**Report to the Resource Consents Hearing Commissioner
on a Publicly Notified Resource Consent**

Site Address:	1 Molesworth Street, Pipitea
Legal Description:	Section 1 SO Plan 38114
Applicant:	His Majesty the King C/- Simpson Grierson
Owner(s):	His Majesty the King
Proposal:	Construction and use of new buildings with associated site works and modifications
Activity Status:	Discretionary Activity

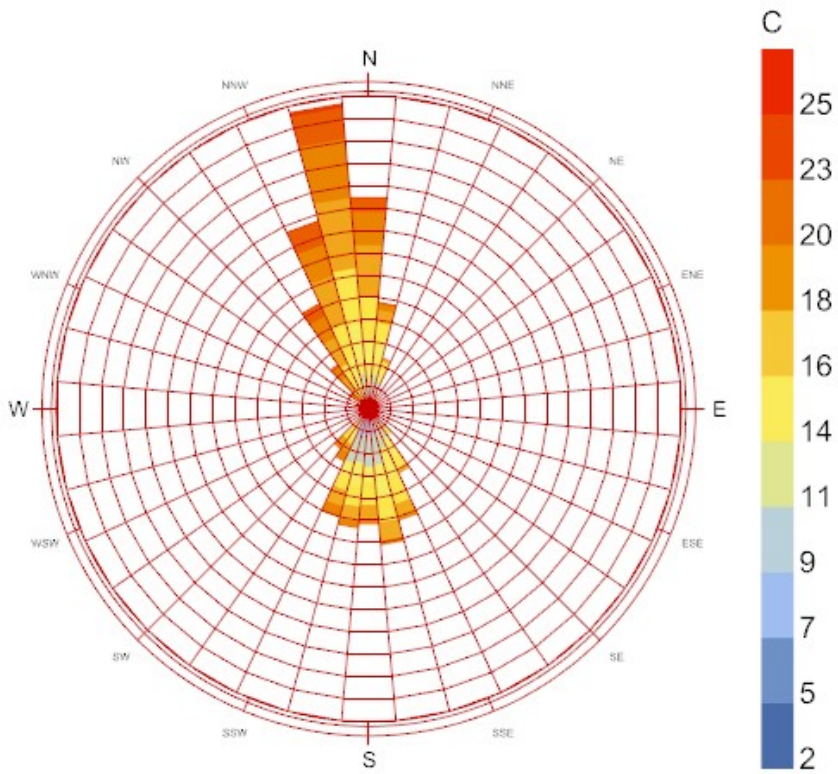
The urban design assessment has nothing helpful to say on the issues of the usability of the external environments created by the buildings' placements: *"Wind effects are beyond the scope of this report. However, elevated wind speeds have been identified in the report by WSP Ltd. Any mitigation of this condition – using trees or constructed shelters and the like - will need to: address CPTED issues, avoid crowding the relocated heritage oak, and avoid splitting the courtyard longitudinally into two discrete spaces"*

This overall assessment comes together in the AEE document: *"Wind speeds in localised areas can be reduced when screens for example are orientated at right angles across the ground level wind flows. However, for other reasons (i.e. CPTED, maintaining pedestrian access, adverse visual effects etc) they may not be practical. The report finds that "taken overall, wind conditions are improved with the proposed development" (p23).*

"For the proposed pedestrian areas, at the detail design stage it is proposed that wind mitigation along with other design factors (such as visual effects, CPTED, security considerations etc) will be further considered and assessed with the objective of making the proposed pedestrian areas as safe and attractive as practicable."

QUESTIONS:

Figure 2: Proposed New Museum Street Building housing diesel fuel supply in basement

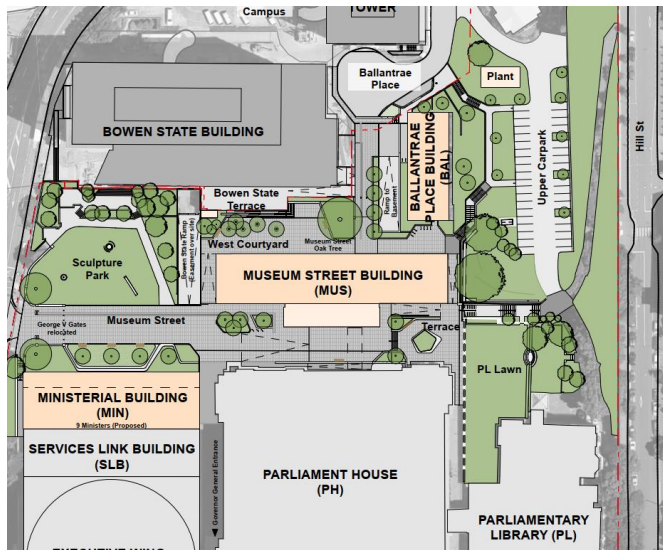
The document is intended as a peer review of the management and appropriate considerations for the use and storage of hazardous substances within the facility.

Figure 3 Water Supply Map

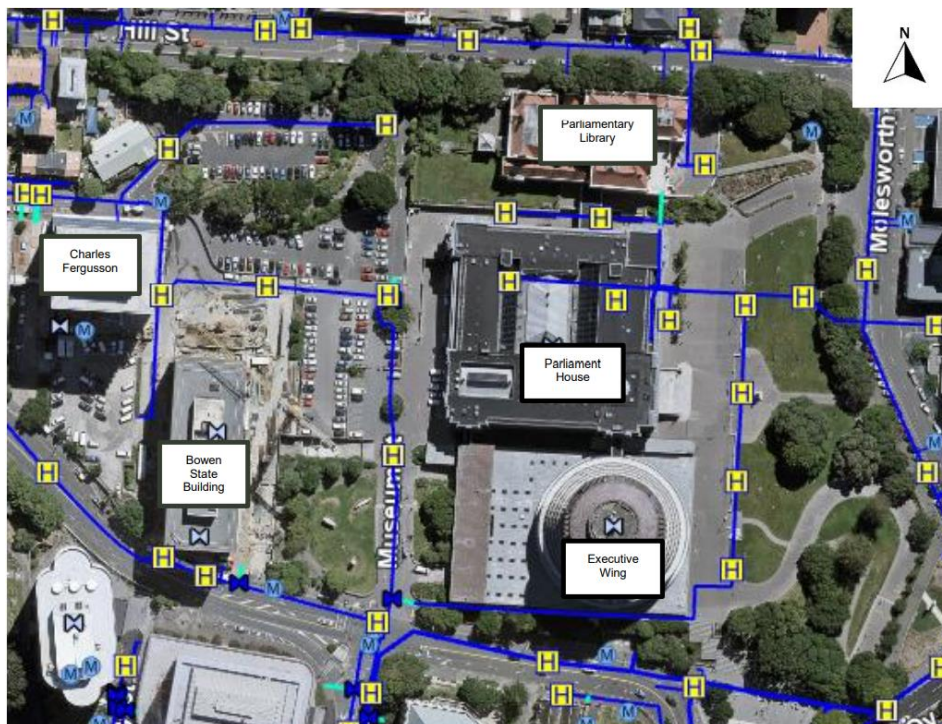
- To allow for the construction of the new Museum Street Building, the existing fire hydrant outlets connected to Parliament House's internal fire protection system require to be temporarily relocated. It is proposed to construct a temporary fire panel and fire supply inlet (FSI) at the southwestern corner of Parliament House. A 150mm steel line will be installed from the sprinkler valve room south to supply the new temporary FSI and indicator panel.

- A connection for this will be taken from the upgraded Ballantrae Place main. It is proposed to connect to a new 150mm ID line in Ballantrae Place to supply the fire panel and potable water connection (which will be capped and buried as part of the enabling works).

Figure 4 Flood Map

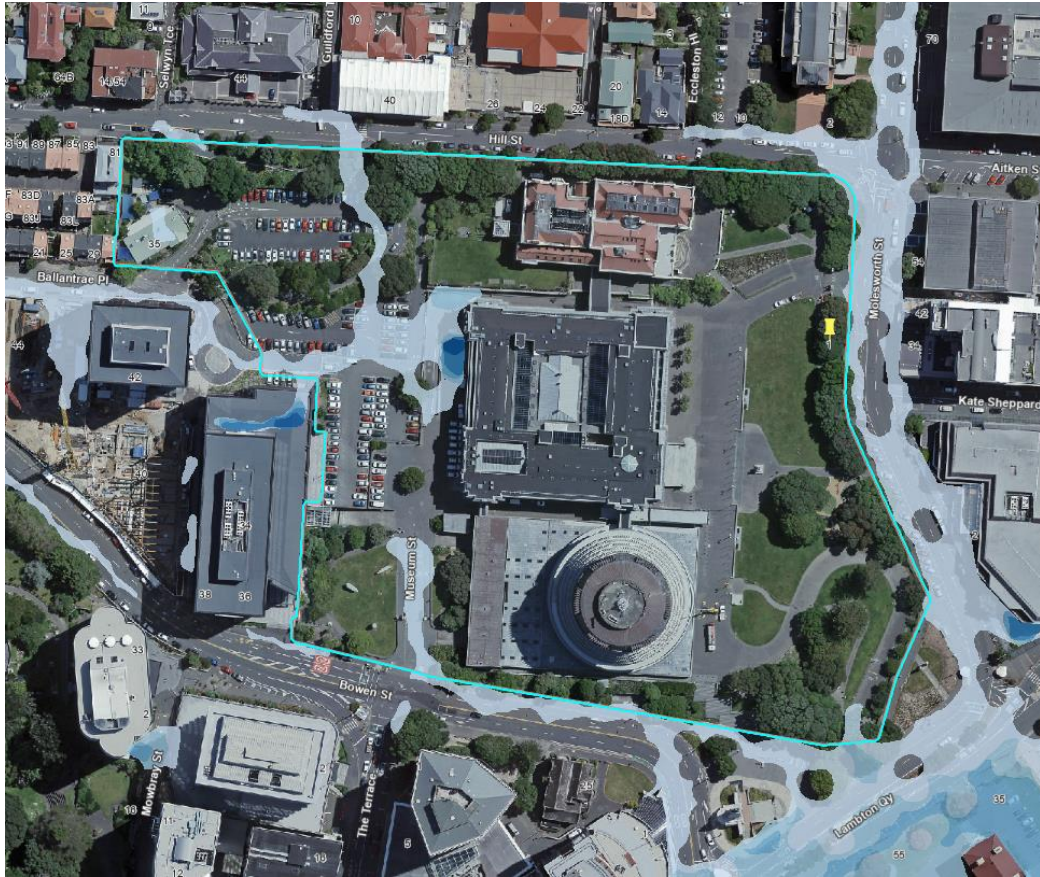
The site is considered within flood prone area. WWL GIS mapping indicates there are overland flow paths and minor flooding within the site in the event of an extreme flood event (1:100 + climate change). These can be managed by maintaining overland flow paths from Hill Street through the site and setting appropriate FFLs for the extreme flood risk.

8. Stormwater neutrality will be required for this development.
9. Earthworks are required to facilitate the development. Site earthworks are predominately associated with excavation for building basements and tunnel connections. Finished surface levels elsewhere on the site will be largely minor. It is intended to reuse clean fill on site where possible, with excess material disposed off-site at appropriate location based on the material classification.
